LOCATION HWY 140 / CNR & CPR STRUCTURES
EMBANKMENT FAILURE

Re: Slope Flattening of Approach Embankment
Highway 140, C.N.R. Overhead Structure
W.P. 174-87-00, Site 34-232
District 4, Burlington

Subject: Instability of Approach Embankments
Highway 140, CNR Overhead Structure
W.P. 174-87-00, Site No. 34-232
District 4, Burlington

FIG No 1

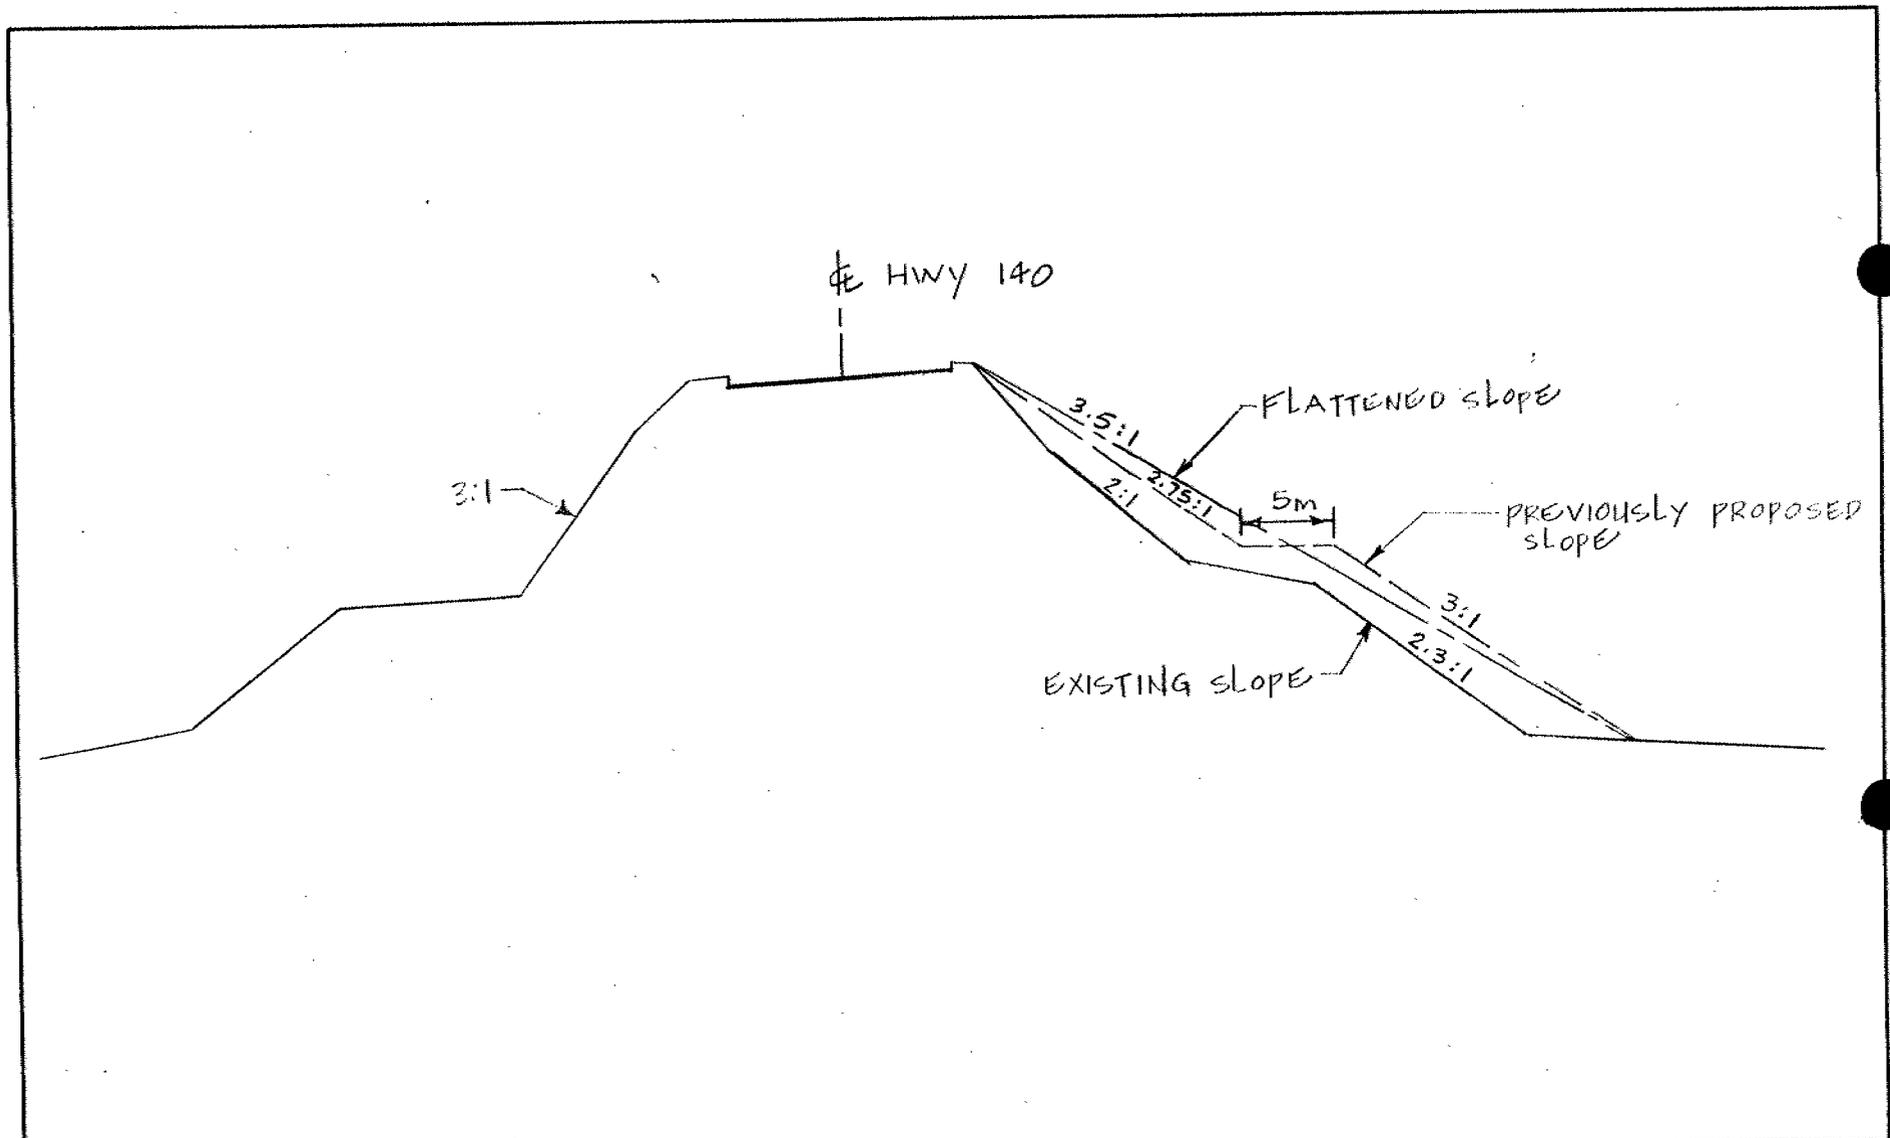
It is understood that the District Office wants to eliminate the 5 m wide mid-height berm which was recommended in our previous recommendations (a memo dated November 14, 1991) and, instead, to flatten the embankment slope toward transverse direction. Figure 1 shows an existing cross section, previously proposed section with the mid-height berm, and a flattened slope with a 3:5H:1V geometry. As shown on Figure 1 if the 3.5H:1V slope superimposes on the previously proposed Section, the toe of two slopes will lie on one another. It is also understood that Granular 'A' or 'B' material will be used as an additional fill material with a minimum granular blanket thickness of about 0.6 m.

- 1) For fills higher than 5 m, permanent slopes will be stable at 3.5H:1V side slopes.
- 2) For fills higher than 3.5 m and equal to or lower than 5 m, permanent slopes will be stable with side slopes of 3H:1V.
- 3) For fills equal to or lower than 3.5 m, permanent slopes will be stable provided side slopes of 2.5H:1V.

FIG - 2
WP 174-87-00

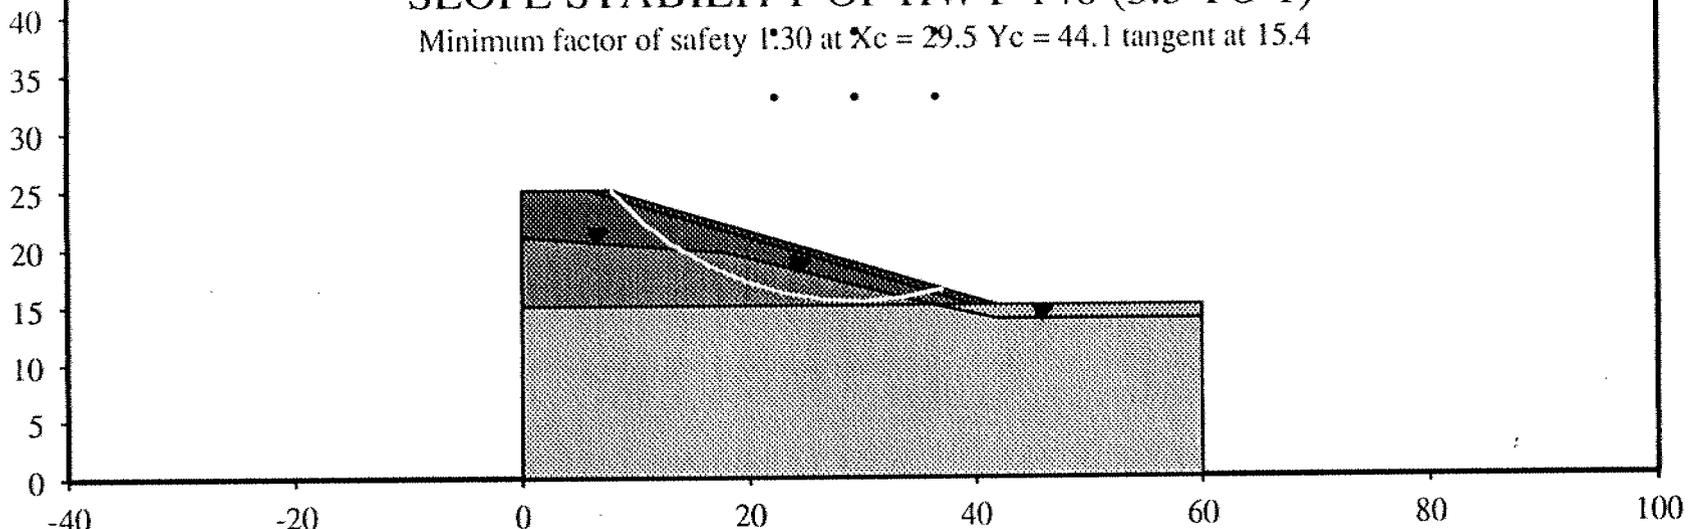
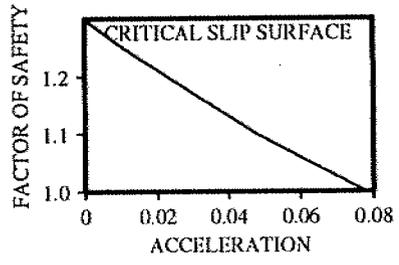
SLOPE STABILITY OF HWY 140 (3.5 TO 1)

Minimum factor of safety 1.30 at $X_c = 29.5$ $Y_c = 44.1$ tangent at 15.4

PHOTO #1. NORTH ABUTMENT (LOOKING WEST)

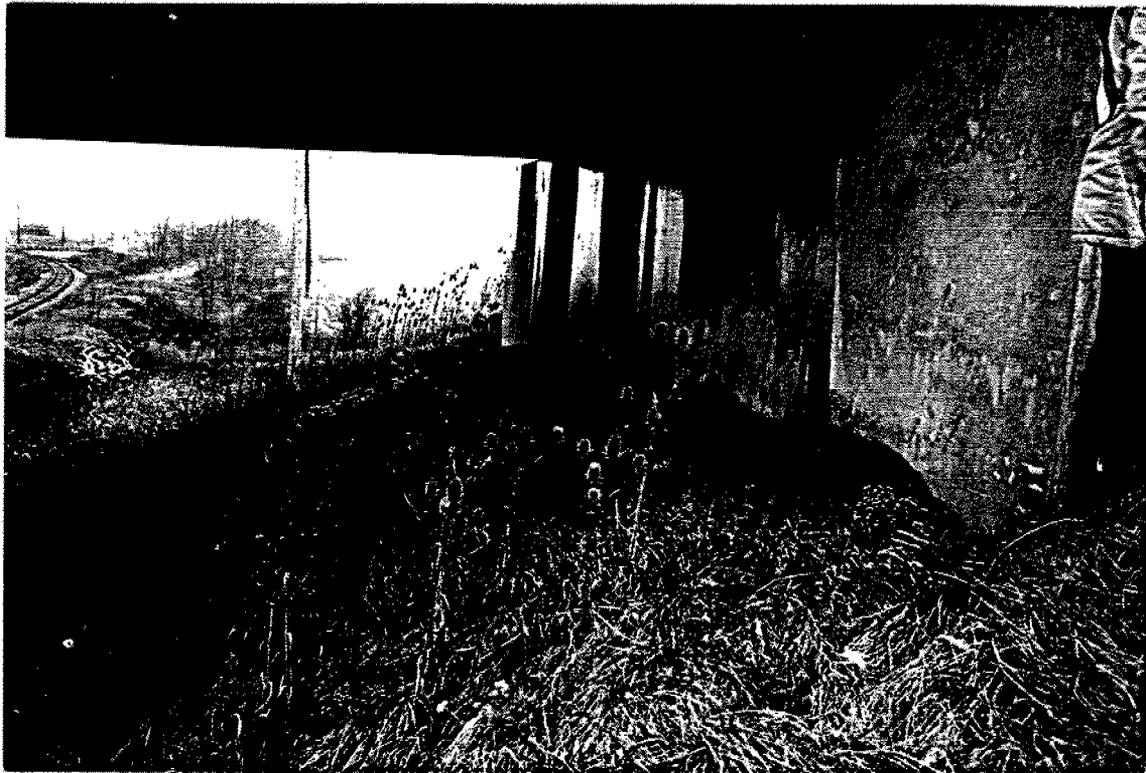
1. The void between the concrete abutment and the earth fill at the north abutment had been backfilled with cohesive soil by MTO maintenance crew when we visited the site (see photo #1).
2. Localized surficial sloughing was noted on the portion of the upper slope (2:1) above the berm, particularly the east and west side of the north approach fill (see photos #2 and #3). However, it would appear that these conditions are confined to an area where the Granular 'A' blanket was placed.
3. The 2:1 slope, below the berm appears to be reasonably stable.

PHOTO #4. LONGITUDINAL CRACKS ON NORTH
APPROACH (EAST SIDE, LOOKING SOUTH)

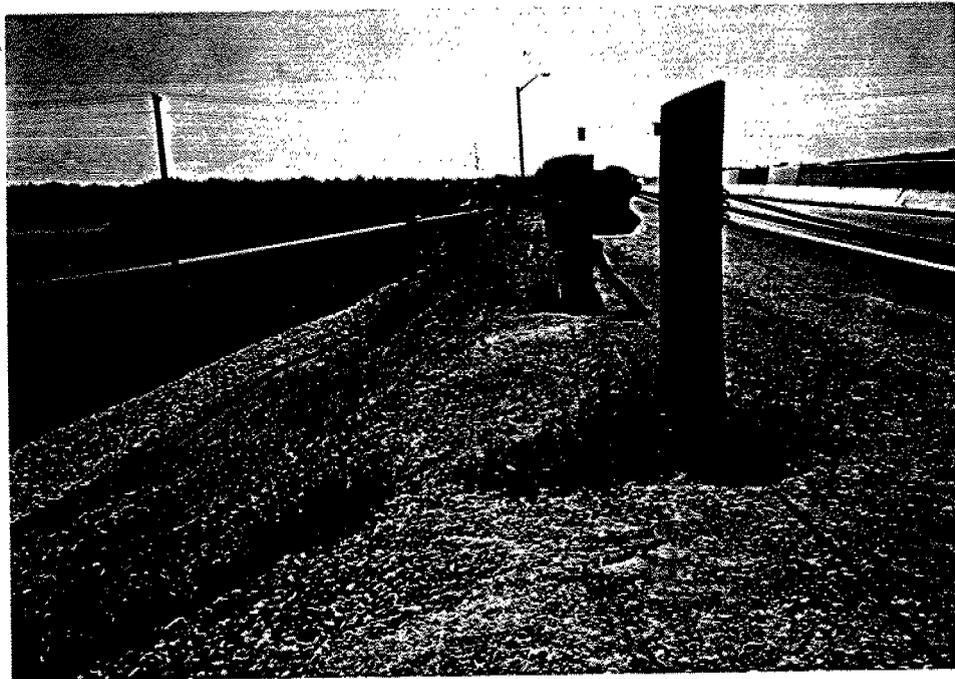
1. Tension cracks, running parallel to the roadway, were noticed at both sides on the upper slopes. These cracks generally are present along the shoulder, outside of guide rail, and extended to about 200 m north from the end of concrete slab. The District Construction personnel have indicated that these cracks were originally minor (0.3 cm); however, they were as wide as 5 cm near the bridge abutment during the time of this site visit (see photos #4, #5 and #6).

PHOTO # 7. SURFICIAL SLOUGHING AT
NORTH APPROACH FILL
(EAST SIDE, LOOKING NORTH)

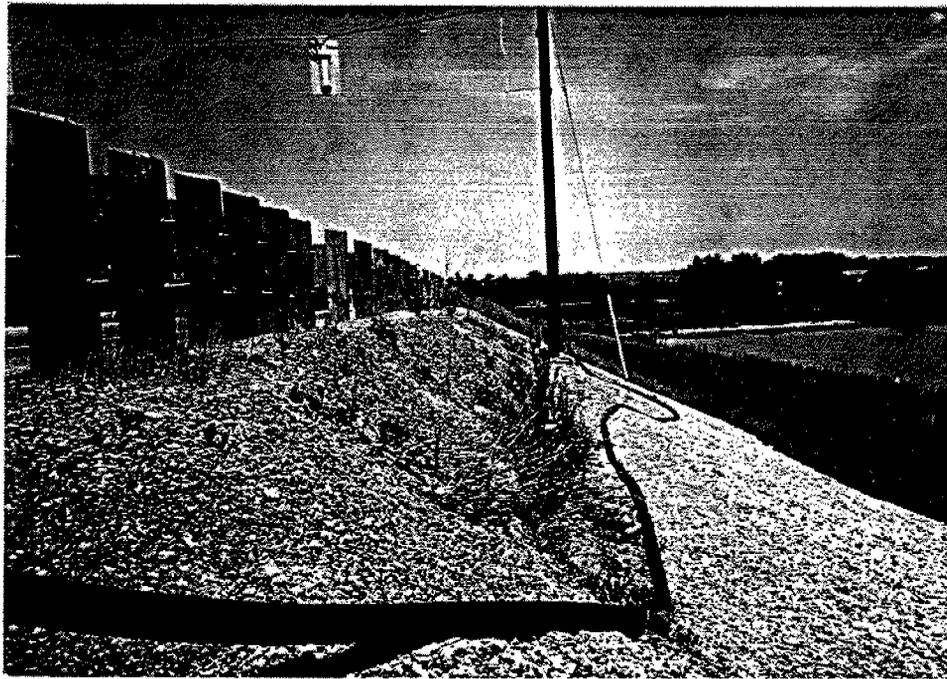
2. It was found that localized surficial sloughing was further extended to the north (about 30 m long) on the upper slope above the mid-height berm, particularly the east side of the north approach fill (see photo #7).

FIG No 1

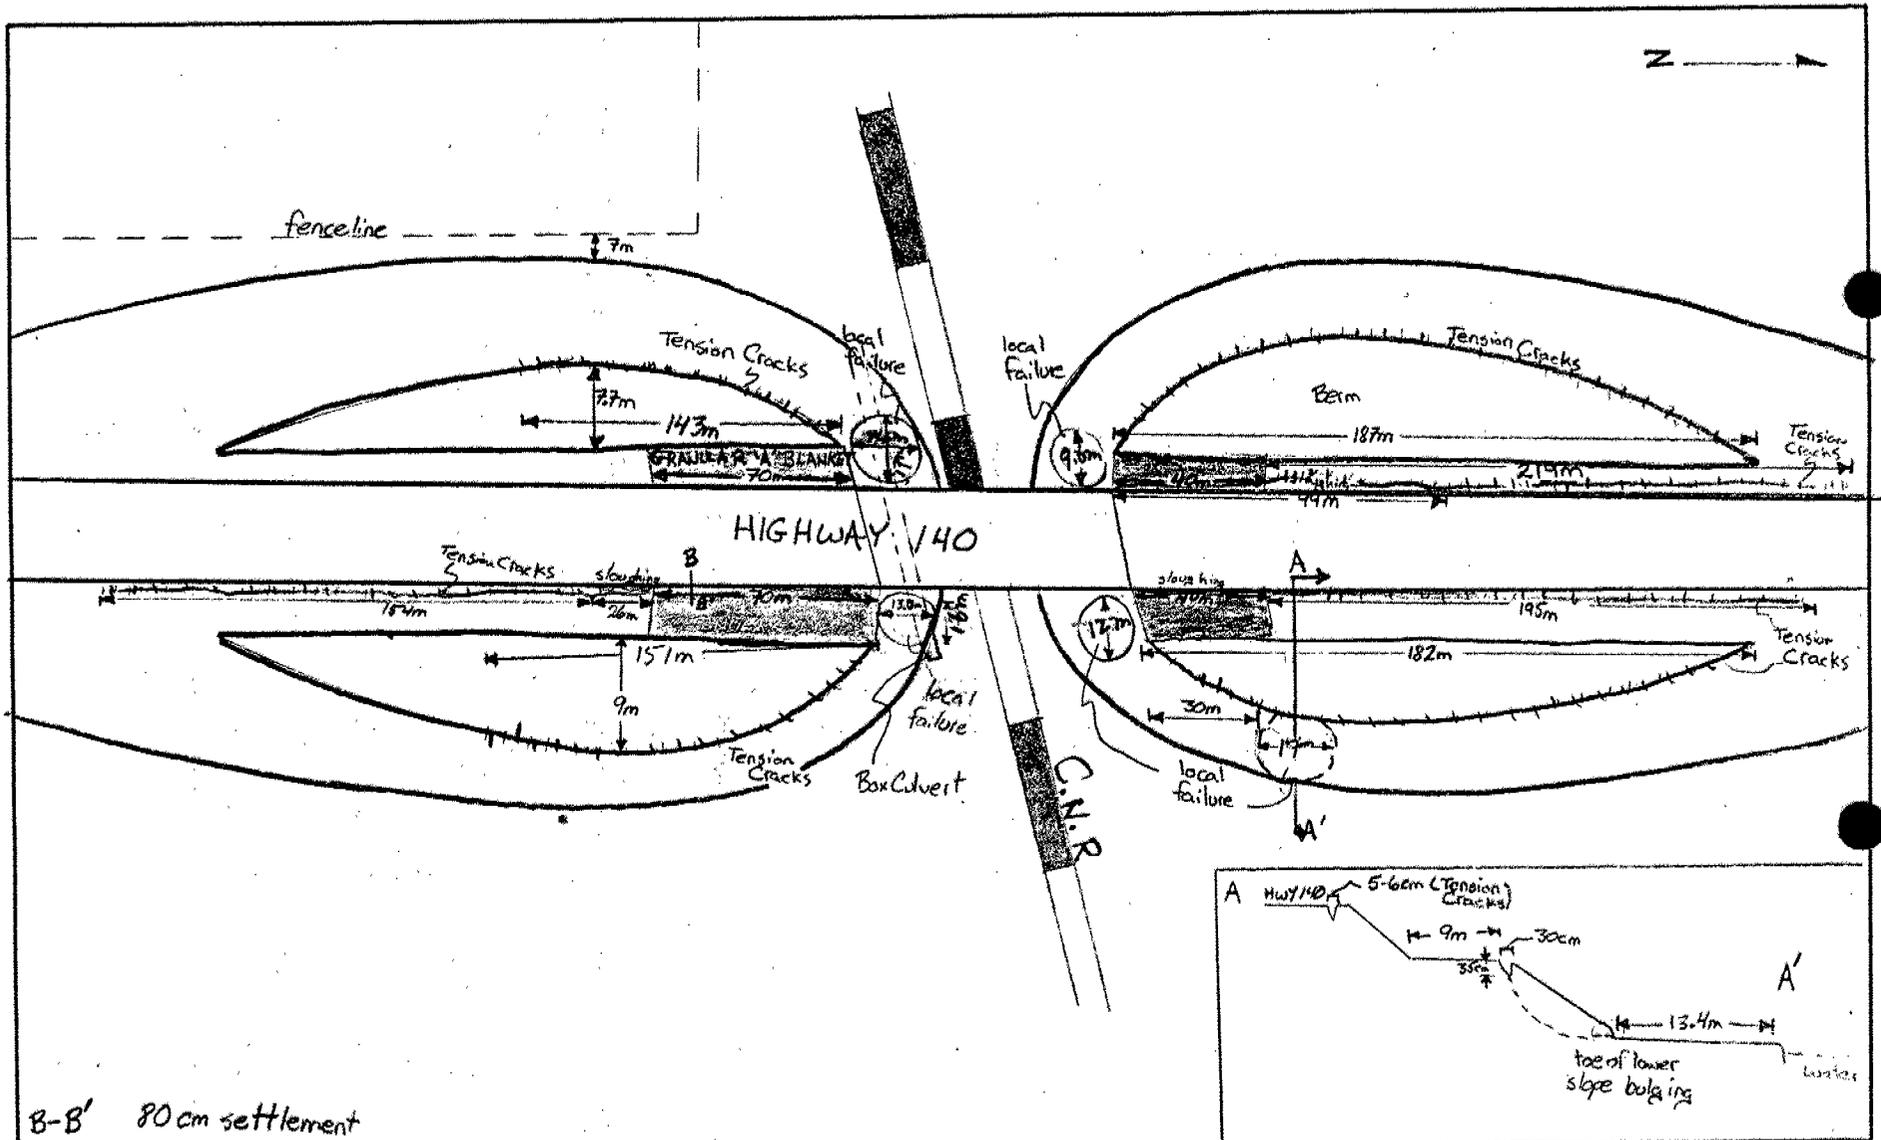
Subsequent site visit made on October 17, 1991 by Messrs T. Kim and A. Drevininkas brought forth the following observations (see Figure 1)

1. Tension cracks, running parallel to the roadway, were noticed on the upper slopes of the north approach fill and the east side of the south approach fill. These cracks are generally present along the shoulder, outside of the guiderail,

extending to about 260 m north of the north abutment and extending 250 m south of the south abutment. The size of these tension cracks are 5-6 cm in width, with those on the north approach fill being more prominent.

2. Tension cracks, running parallel to the those on the upper slopes, were also detected on all of the lower slopes along the edge of the mid-height berm. These cracks are between 140 m and 190 m in length, running the whole length of the mid-height berm (185 m) on the north approach fill.

3. Localized surficial sloughing was found to the north (about 100 m long) and to the south (about 25 m long) on the upper slope above the mid-height berm. The amount of settlement along the upper slope of the south approach fill was as much as 80 cm.
